### STAFF RECOMMENDATION 1511 16<sup>th</sup> Avenue South August 21, 2019

**Application:** New Construction—Infill  
**District:** South Music Row Neighborhood Conservation Zoning Overlay  
**Council District:** 19  
**Base Zoning:** OR20  
**Map and Parcel Number:** 10408032700  
**Applicant:** Preston Quirk  
**Project Lead:** Melissa Sajid, [melissa.sajid@nashville.gov](mailto:melissa.sajid@nashville.gov)

**Description of Project:** The request is to construct a second, detached structure on a lot with 130' of frontage.

SITE PLAN

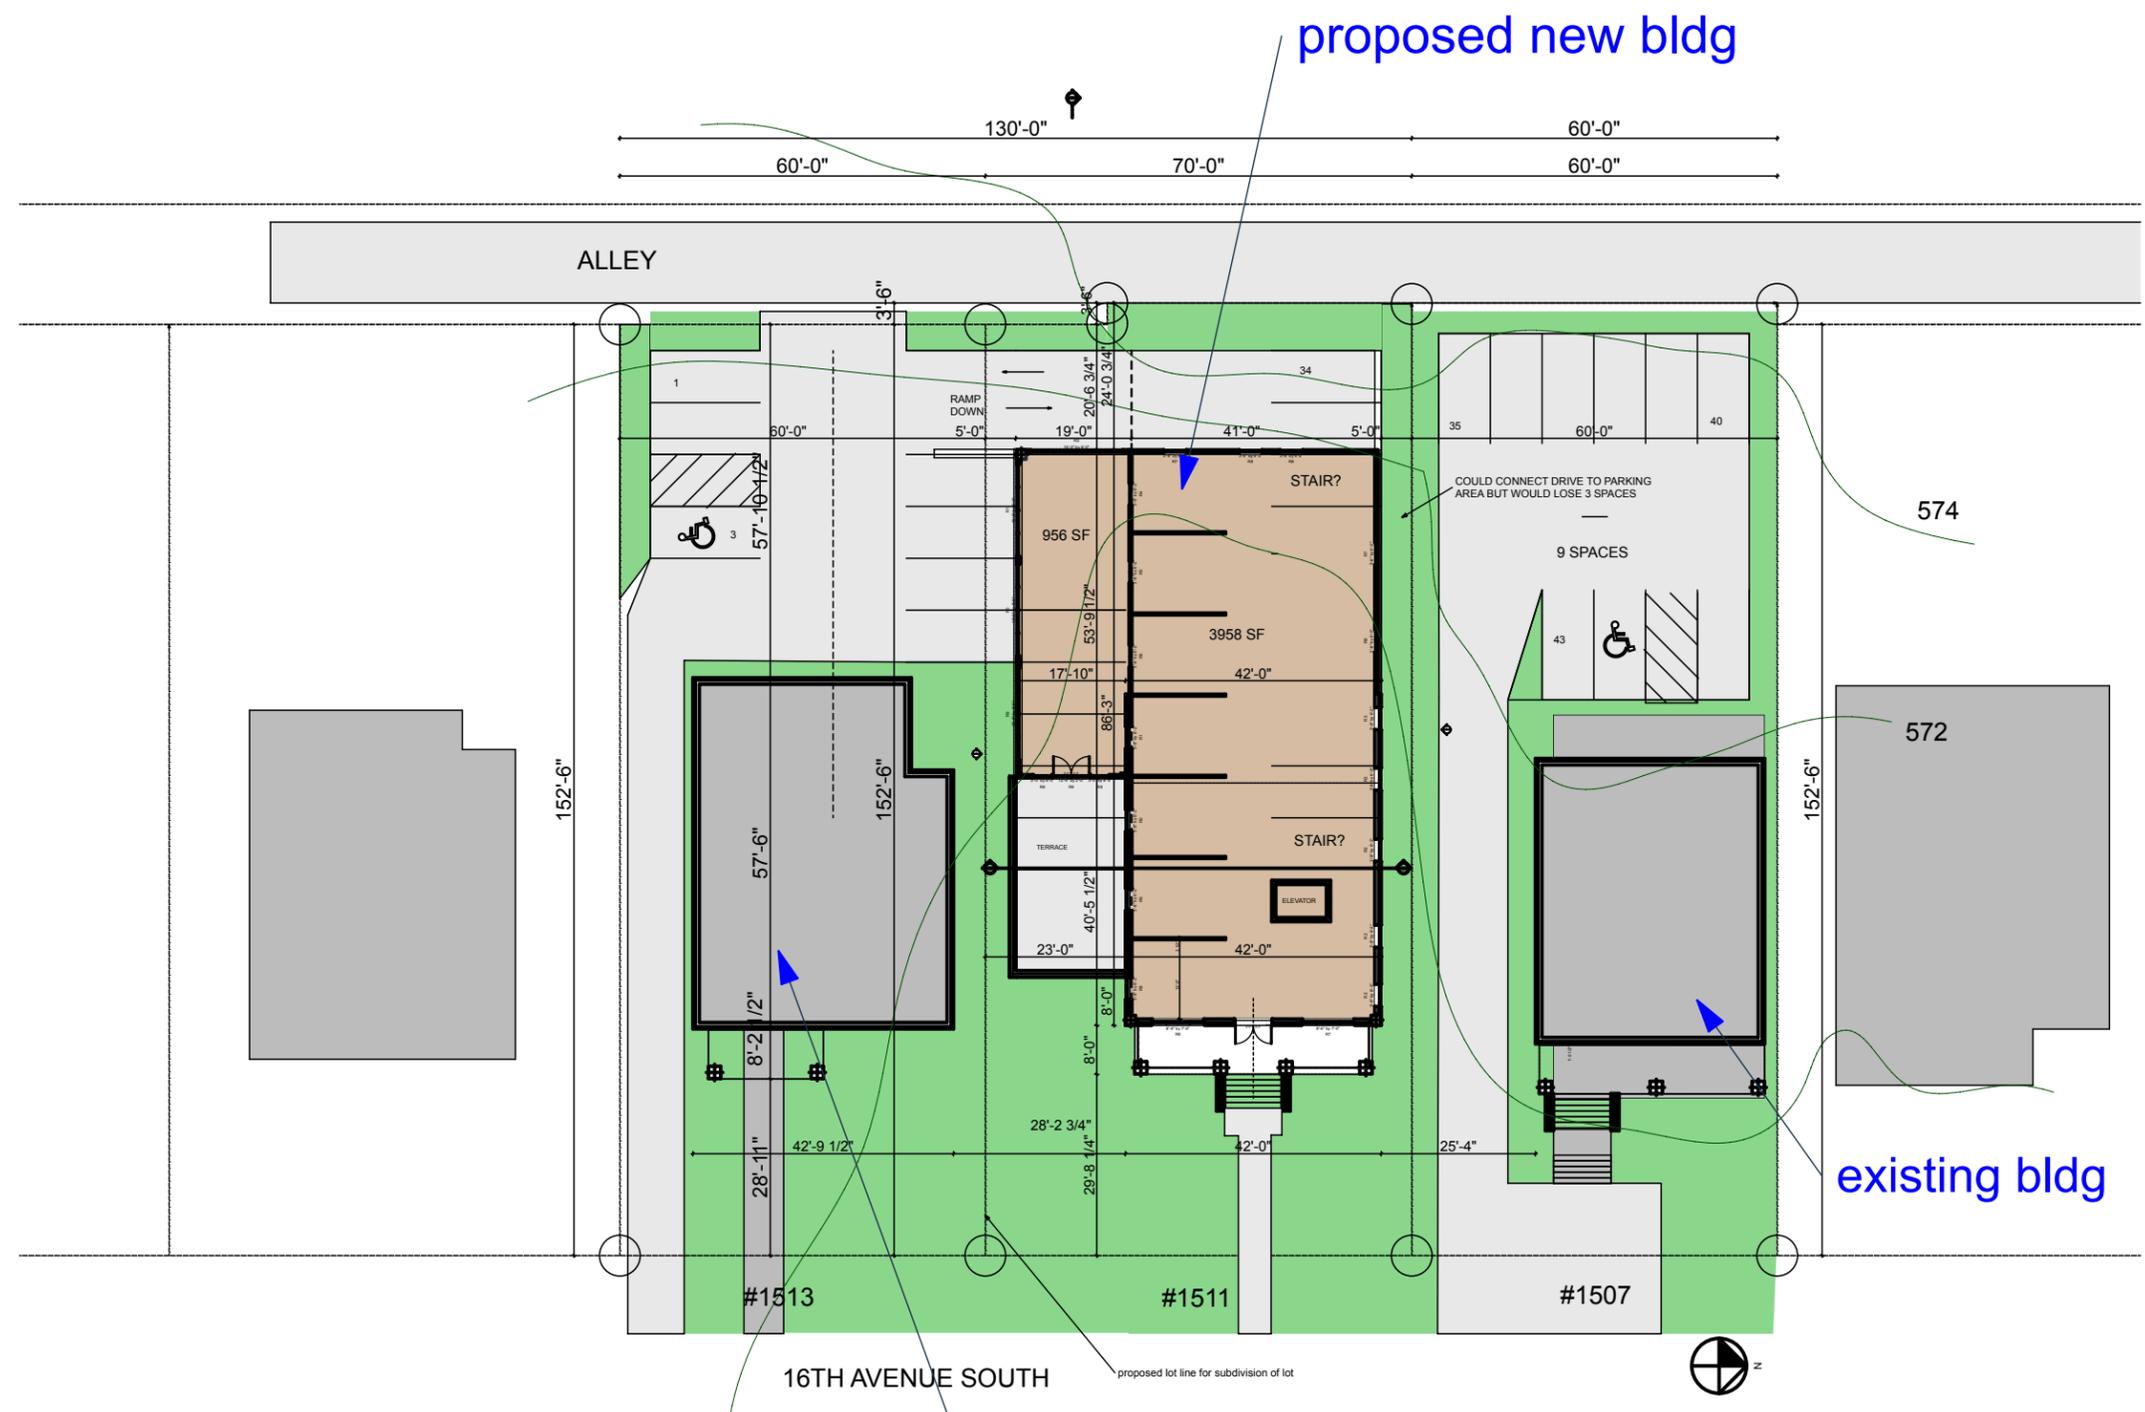
Appurtenances & Utilities: Vehicular access to the site is primarily from the alley, but parking can also be accessed from the existing curb cut and driveway to the left of the existing historic house on the lot. The lot is mostly flat, and the plan is to grade the site to accommodate most of the parking underground. There is an existing curb cut on the right side of the site that will be removed.

The location of the HVAC and other utilities were not noted on the site plan. Staff asks that the HVAC be located on the rear façade, or on a side façade beyond the midpoint of the house. The project meets Section II.B.1.i.

6. Staff approve the masonry color, dimensions and texture; and
7. The HVAC shall be located behind the house or on either side beyond the midpoint of the house, and utility meters shall be located on the sides or rear of the building. Alternative mechanical and utility locations must be approved prior to an administrative sign-off on building permit(s).

ROOF PLAN

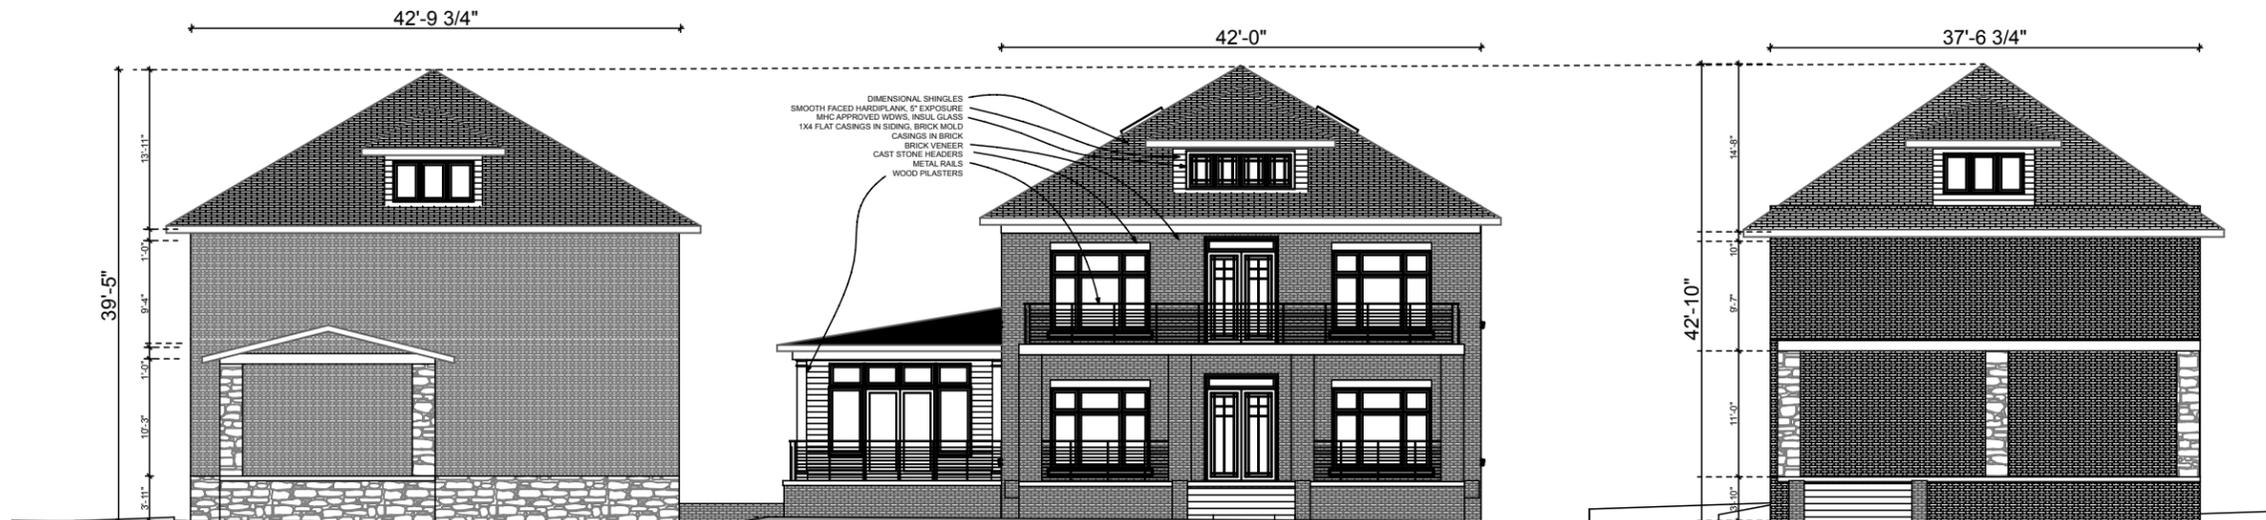
Roof form: The primary roof form of the infill is hipped with a front hipped dormer, both with a 7/12 pitch. The front dormer sets in two feet (2') from the wall below, which meets the design guidelines. The single-story piece on the left side façade has a shed roof with a 2/12 pitch. Flat skylights are incorporated in the roof on both side façades, which can be appropriate. The proposed roof forms and pitches are compatible with historic roof forms in the neighborhood. The project meets Section II.B.1.d.

ELEV - FRONT, REAR

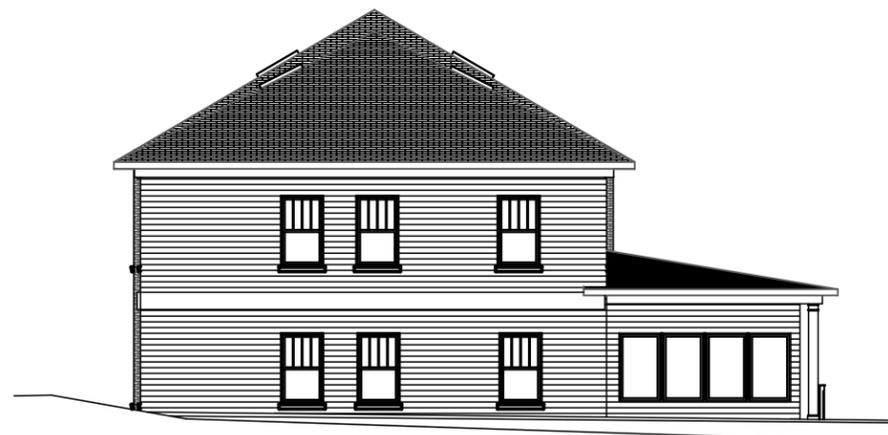
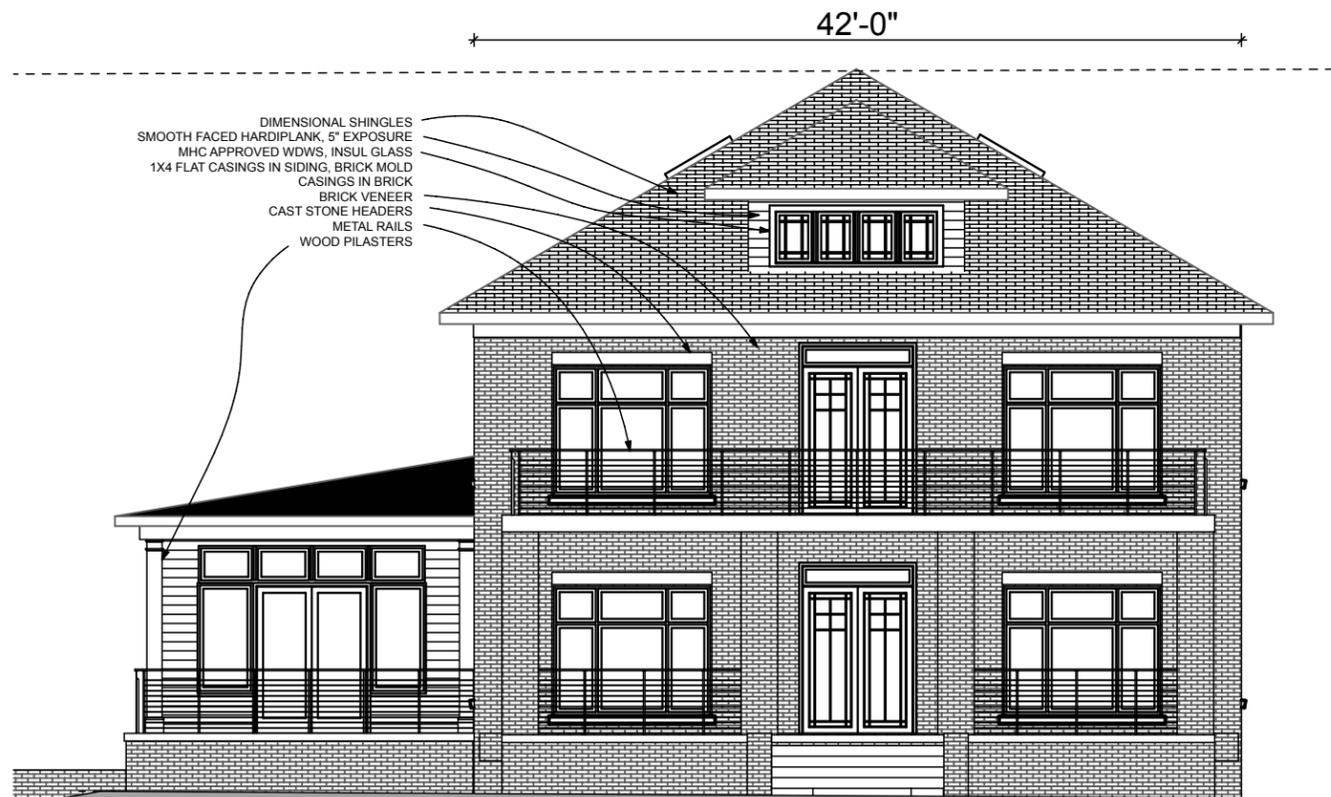
The new structure is two and a half stories with an overall height of approximately thirty-nine feet, ten inches (39'-10"), measured from grade to ridge. The historic character of the block has a wide range of building forms including one, one and one-half, two, and two and one-half story forms. The heights of historic buildings range from approximately twenty-two to forty-three feet (22' – 43'), and according to the scaled streetscape on sheet A6 of the plans, the ridge height of the infill will be no taller than those of the historic structures located to the left and right. Staff finds that the proposed

All the known materials meet the design guidelines. The primary cladding for the infill is brick, and while not specifically indicated, it appears that the foundation may also be brick. Staff would recommend that the infill not have brick to grade. The historic brick structures on either side of the site have stone foundations. Staff recommends using a foundation material other than brick to provide a visual break in materials and to be compatible with the historic context.

2. The ridge height will not exceed the height of the two historic buildings to either side;
3. The front setback should be consistent with the buildings to either side, to be verified by MHZC staff in the field;

4. The infill shall have a different foundation material from the primary cladding material;
5. Staff shall review and approve the final selections for all unknown materials prior to purchase and installation;
